Location
Victoria Embankment Foreshore
City of Westminster

Document Information
Application for Development Consent
Site works parameter plan

Book of plans - section 18
DCO-PP-16X-VCTEF-180008 - Rev 5
Sept 2022

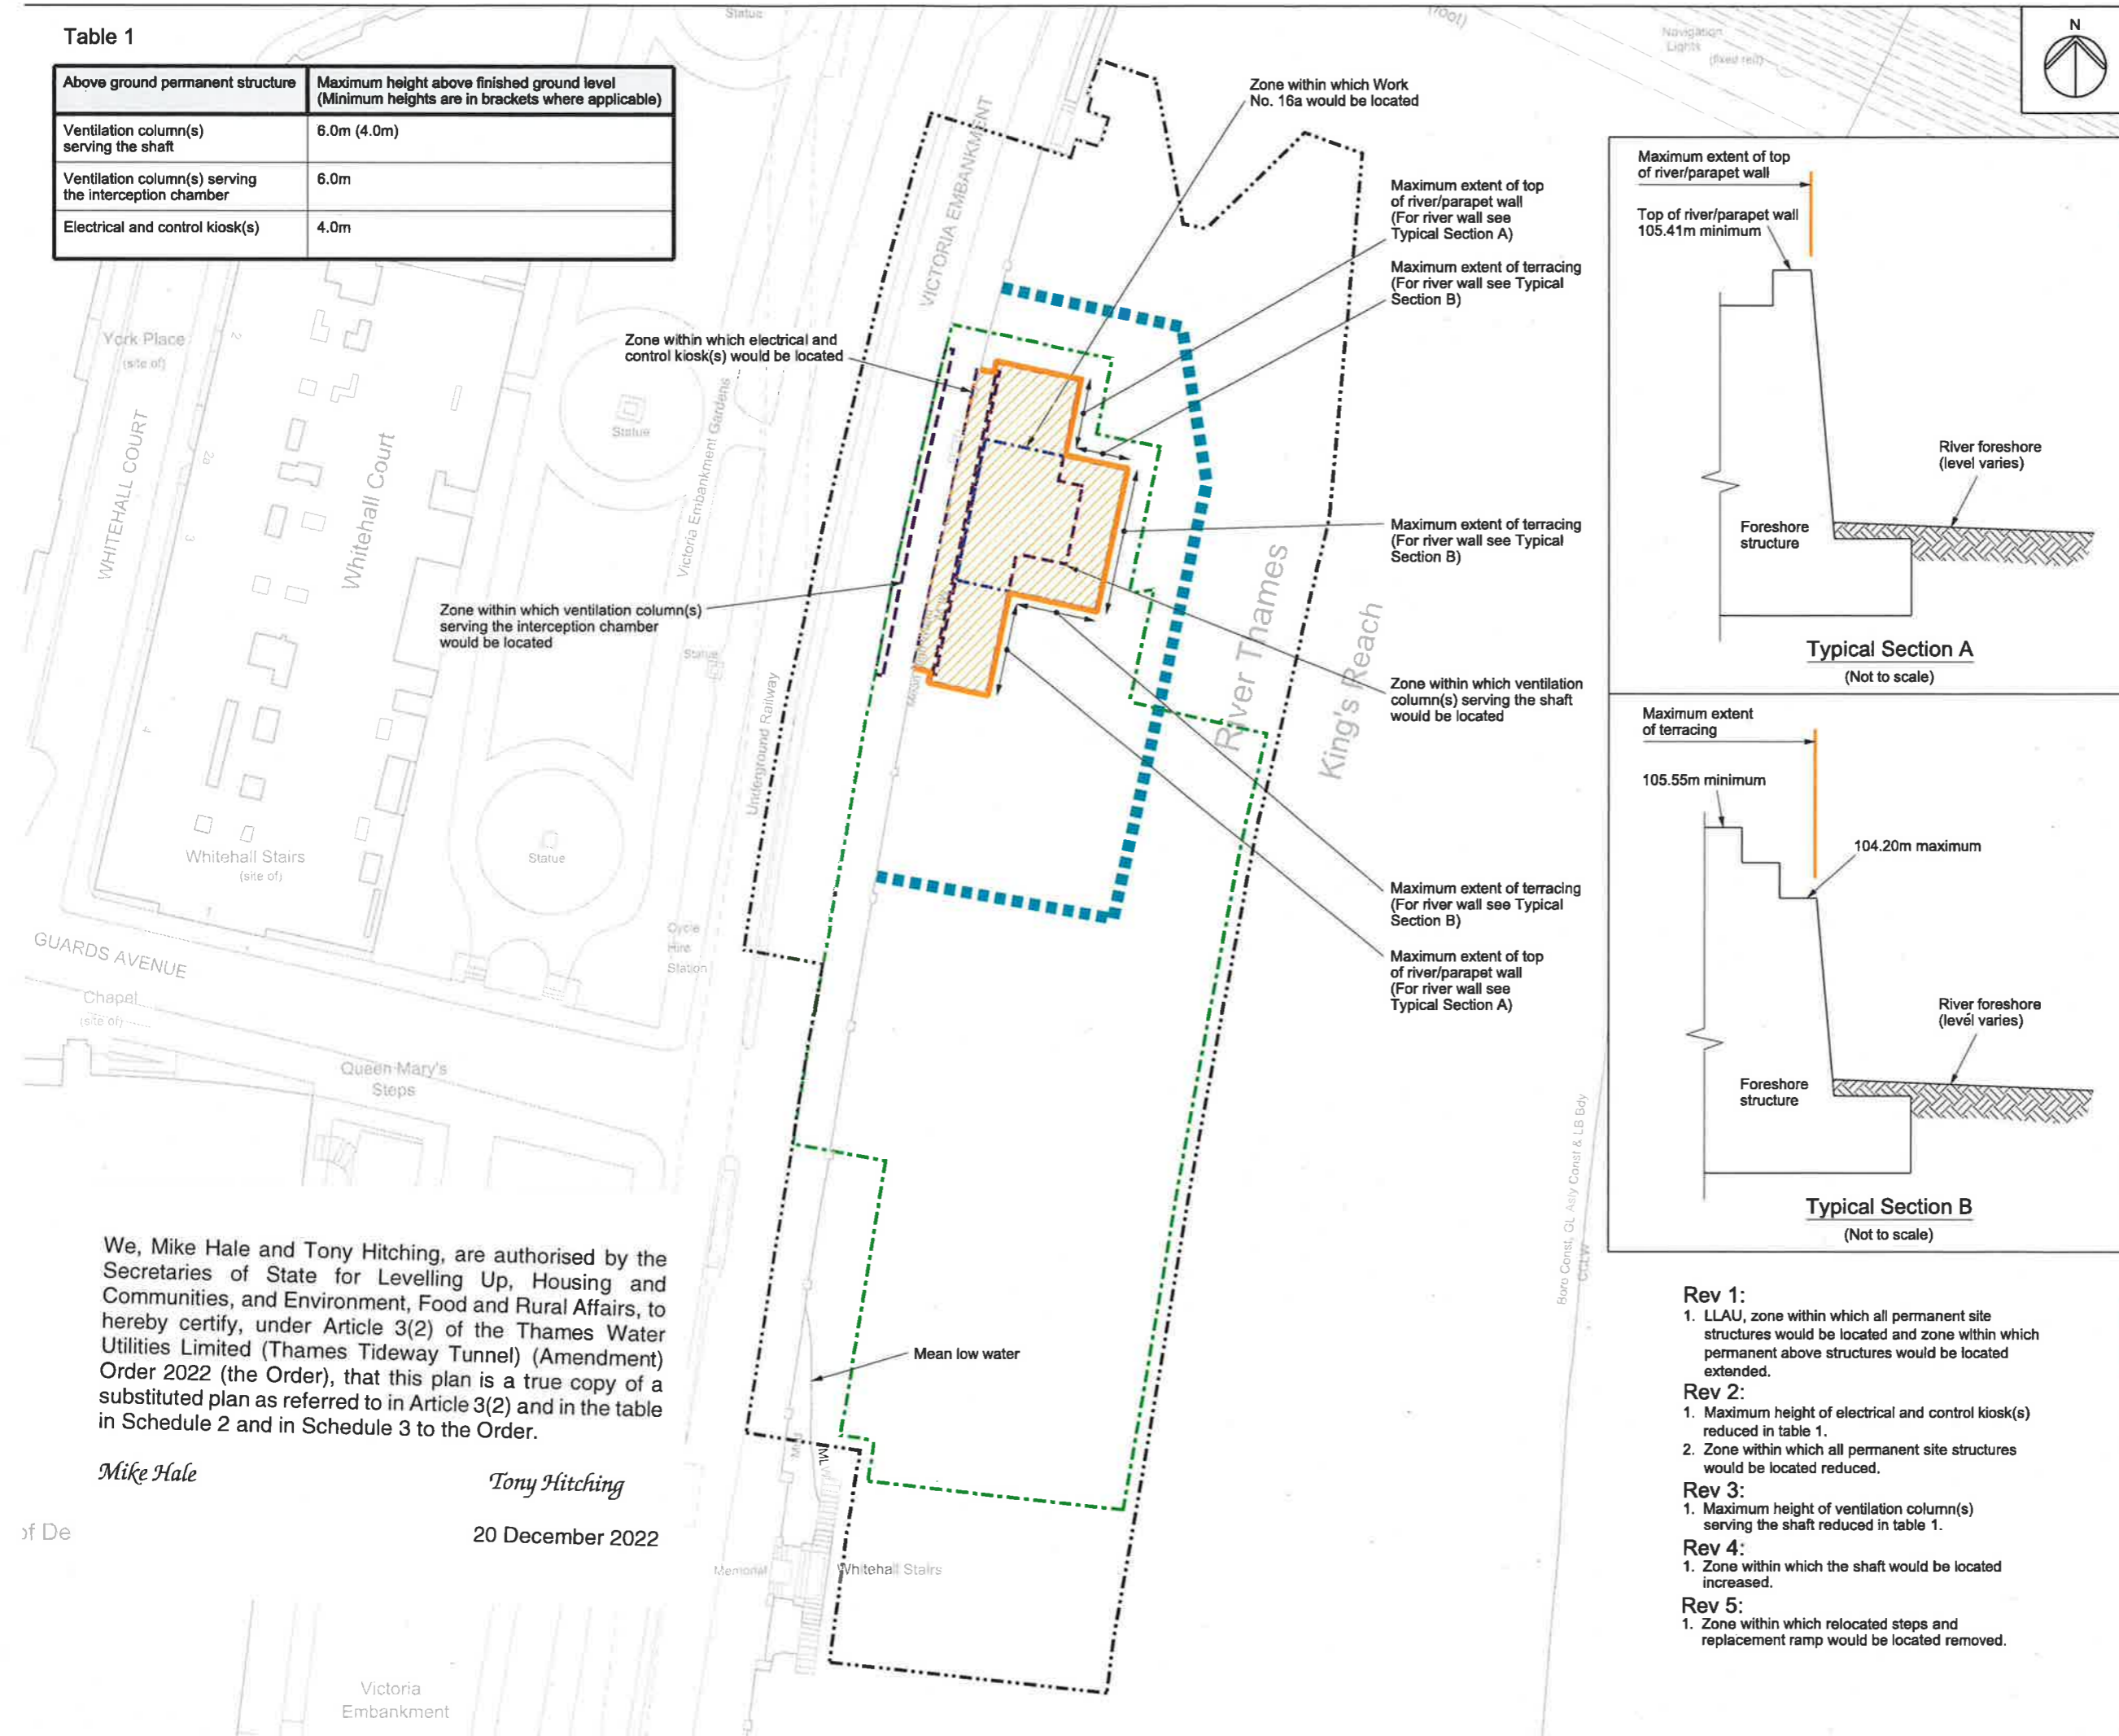
- Rev 1:**
1. LLAU, zone within which all permanent site structures would be located and zone within which permanent above structures would be located extended.
- Rev 2:**
1. Maximum height of electrical and control kiosk(s) reduced in table 1.
2. Zone within which all permanent site structures would be located reduced.
- Rev 3:**
1. Maximum height of ventilation column(s) serving the shaft reduced in table 1.
- Rev 4:**
1. Zone within which the shaft would be located increased.
- Rev 5:**
1. Zone within which relocated steps and replacement ramp would be located removed.
